TRUCK CARGO MEDIUM MC2 - (UNIMOG)  
TRAY SEATING GRAB HANDLE

MODIFICATION INSTRUCTION

FIG 1 - GRAB HANDLE DETAILS

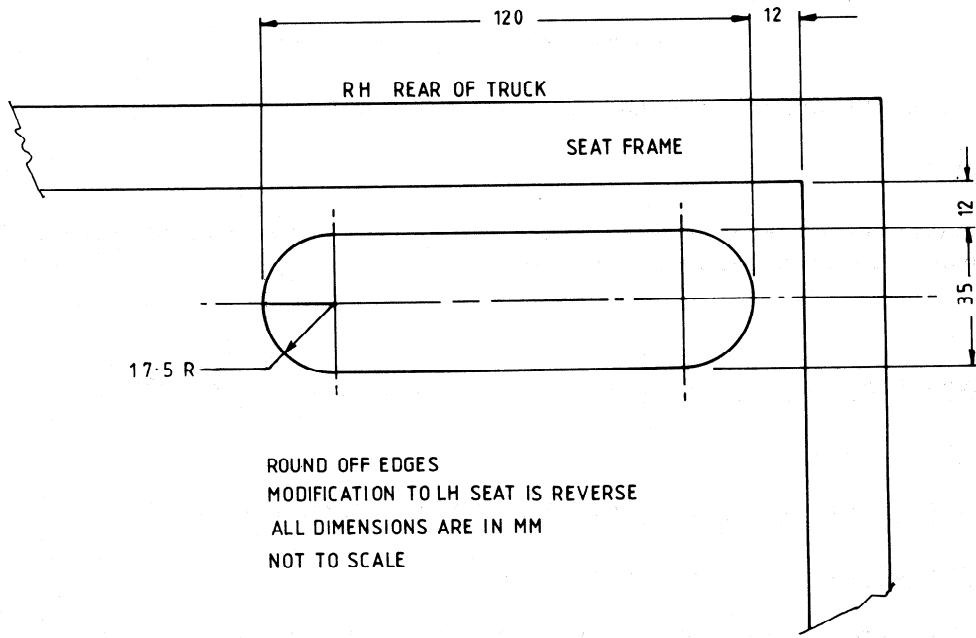
7. To carry out the modification proceed as follows:
  - a. Cut a section from the right and left rear seat panels as shown in Fig 1.
  - b. Paint in accordance with WKSP B 700. Ensure the end grain of the plywood is fully sealed. Finish using ENAMEL, LUSTRLESS, OLIVE DRAB as shown in Fig 2.
8. Modification Record Plate. On completion of the modification deface the numeral 7 from the modification record plate situated on the right hand side of the drivers seat base.
